LETTER OF SUBMITTAL
KFM Skyway Project # 04-012024

Subject: USI - Closing Documents for KFM NCR 114 (METS NCR 99)

Subject: Response to Caltrans State Letter #5.03.1-007551, DTD 04/20/05
KFM NCR #114

Subject: USI NCR No. 99: Bearing Plates Not in Full Contact with the Soffit Plate

TUB SUB-SECTION - 2A - JACKING PLAN

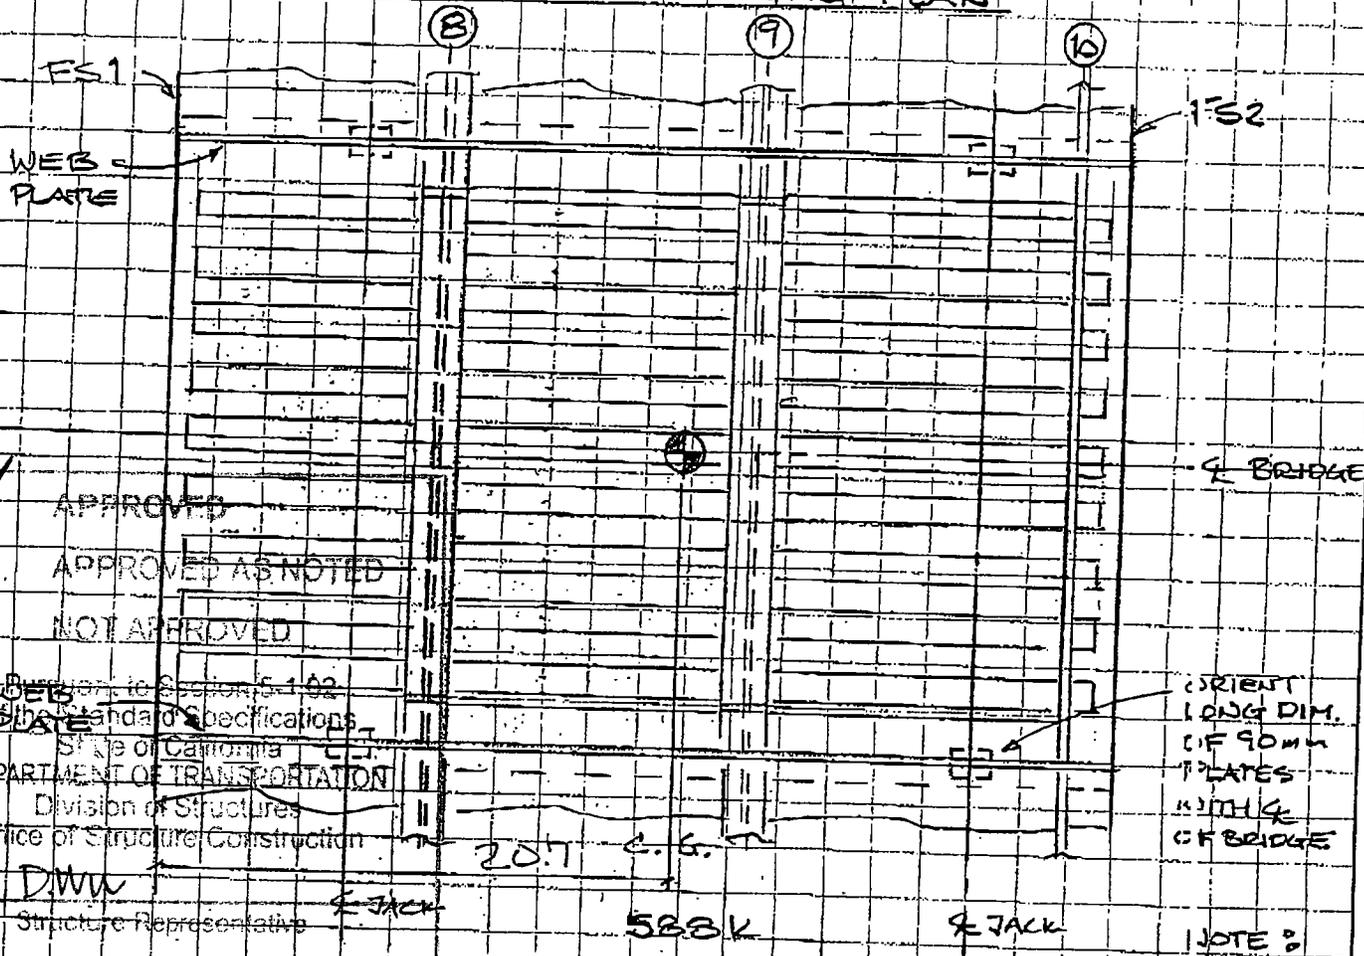
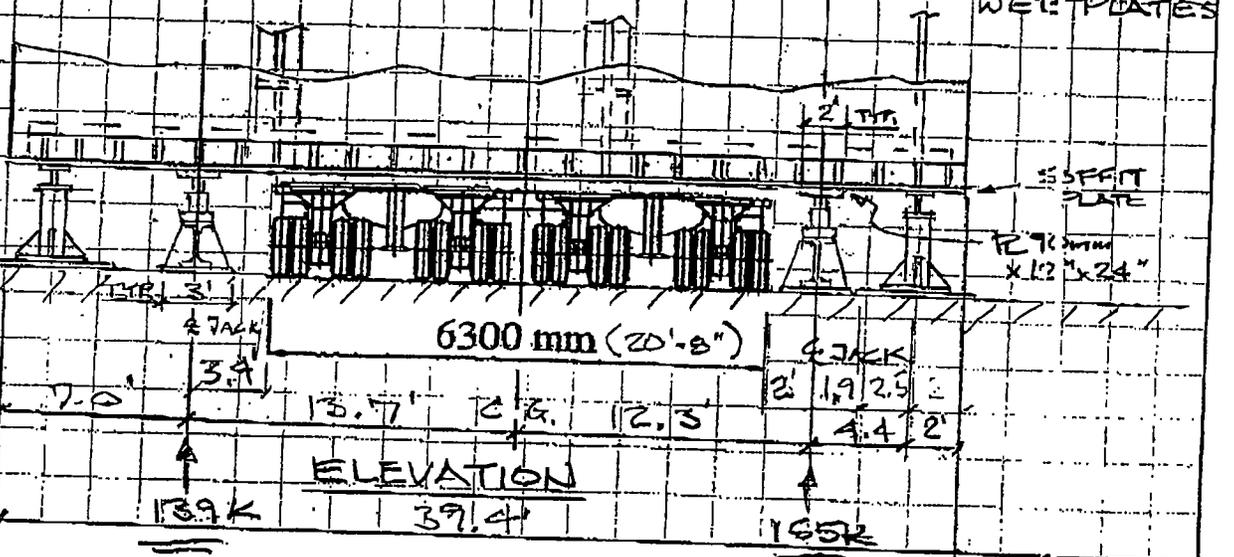
1. KFM's QCM and onsite representative allowed USI to support Assembly 2A differently from the locations and details submitted and approved in KFM-SUB-3599R1. A shim was placed between the bearing plate and soffit plate at the southwest corner resulting in the bearing plates not being in full contact with the soffit plate. The removal of the shim resulted in the sub-assembly being fully supported by only three 90 mm bearing plates. The locations of all four supports also do not appear to comply with the approved submittal.

USI was in error in the placement of a shim between the bearing plate and the soffit plate at the southwest corner of Girder 2A. All parties involved in this incident, including the Bay Foreman and General Foreman have been reprimanded and proper instruction has been given. Great care was taken in the removal and replacement of the shim. Please review the attached information from Smith & Monroe & Gray Engineers dealing with this issue.

4A/ BEFORE MOVE

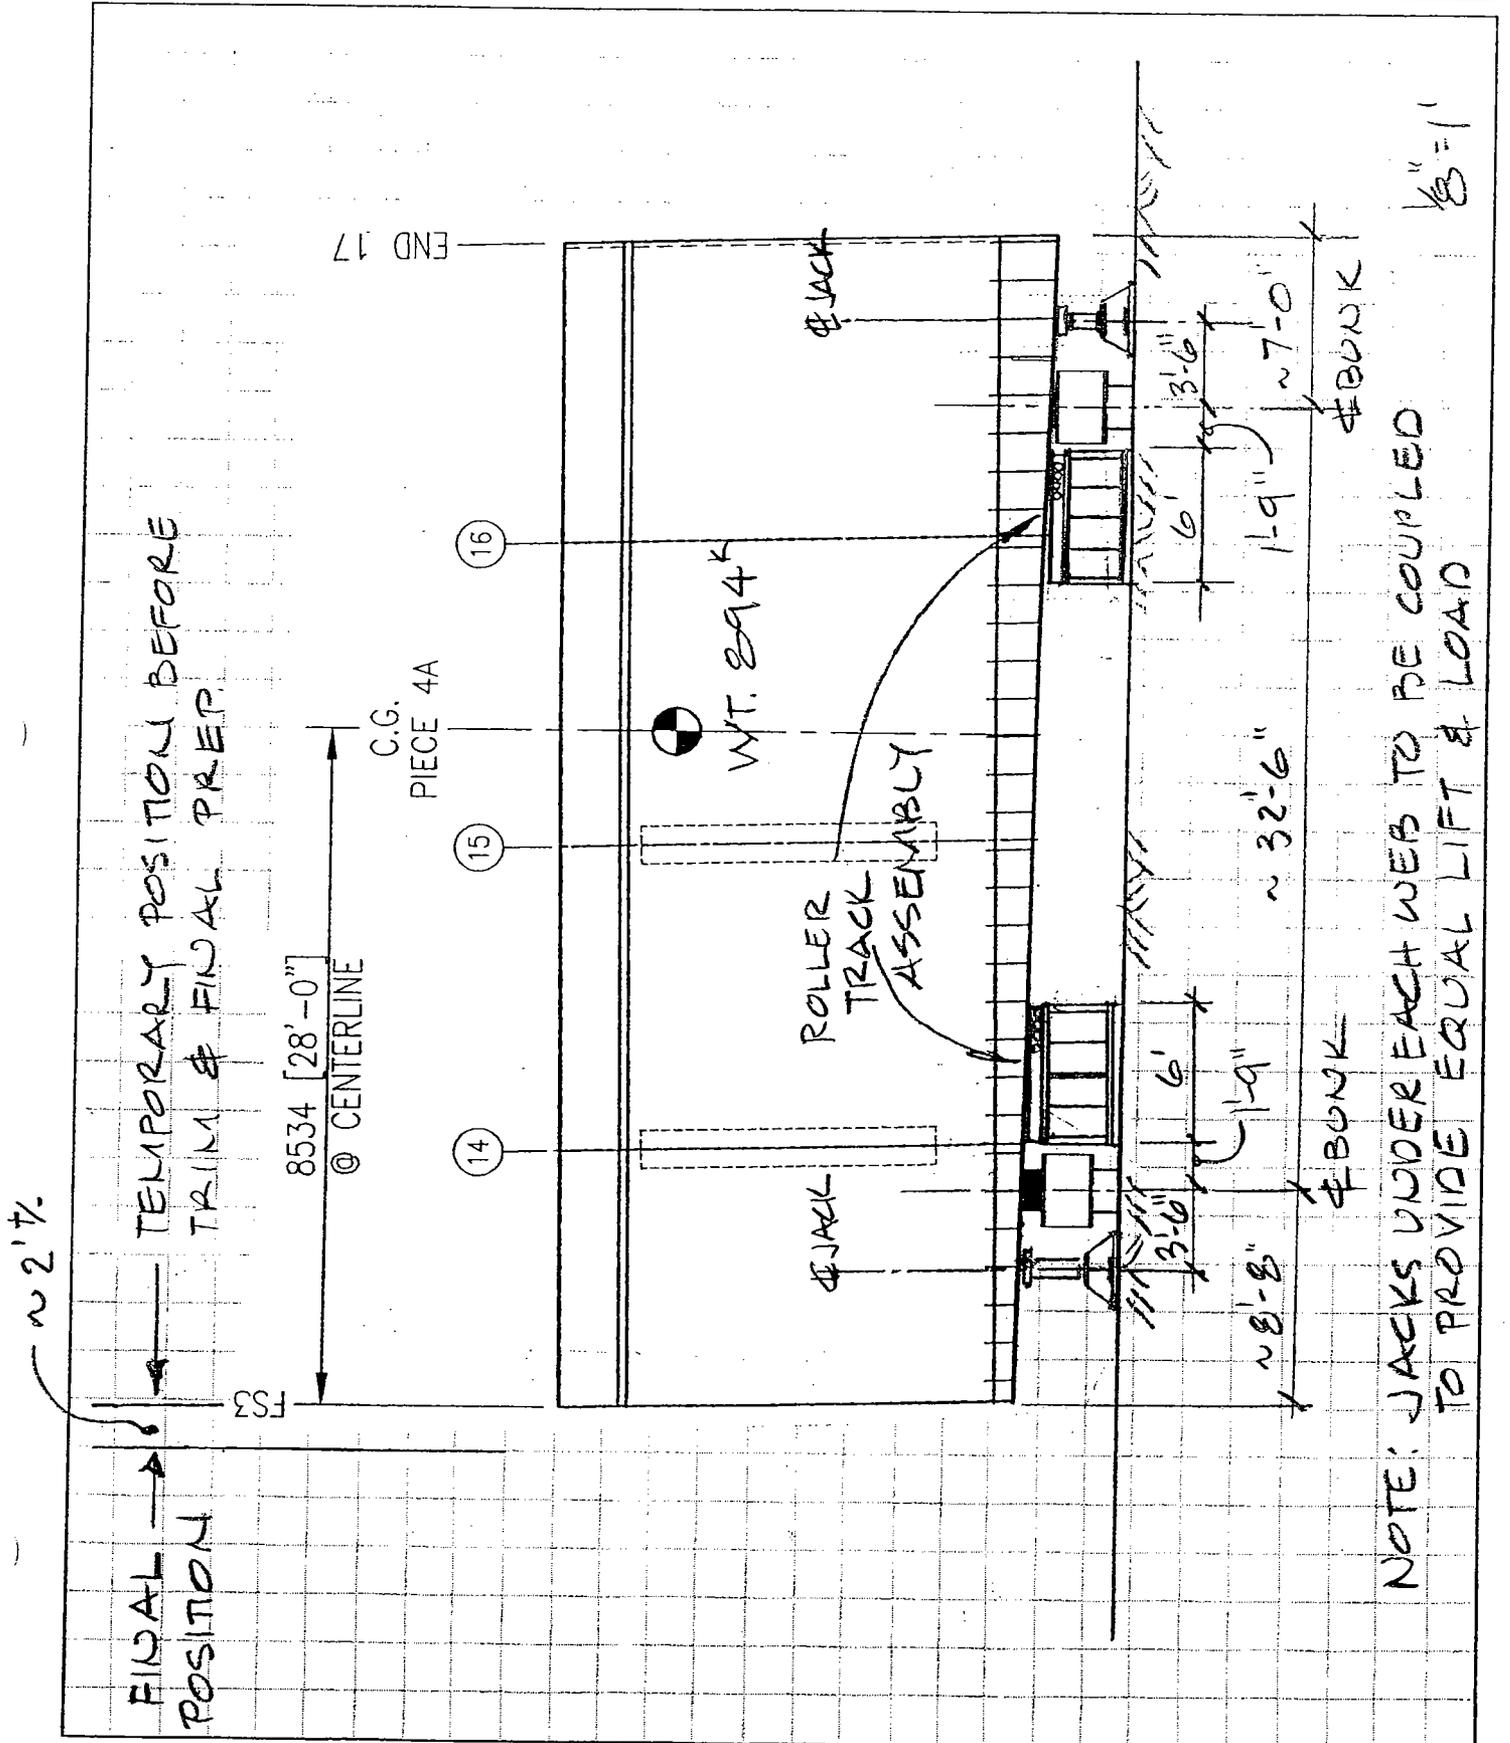
As you requested, we reviewed some support and fit-up details of tub pieces in your yard for assembly. We reviewed your plan to temporarily support the tub pieces about 2 feet from final position then jack and roll to final position after trim and prep. Attached are sketches showing recommended jack and roller assembly locations to assure the tubs are safely supported before final set. Notice the two or three jacks under a common web must be hydraulically coupled/synchronized to provide equal load and lift.

3A

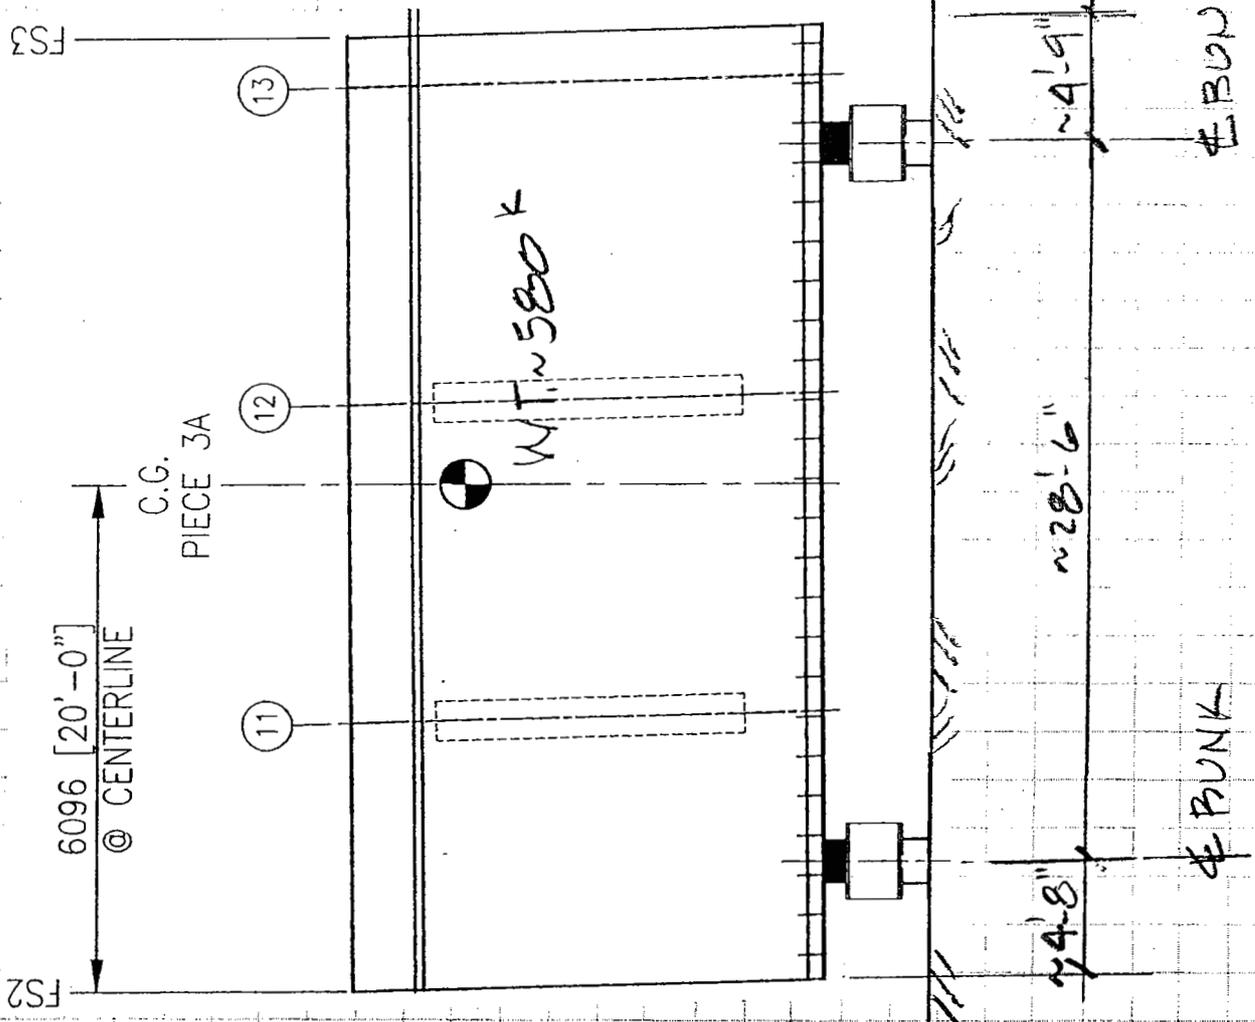
NOTE: PIECE DOES NOT MOVE
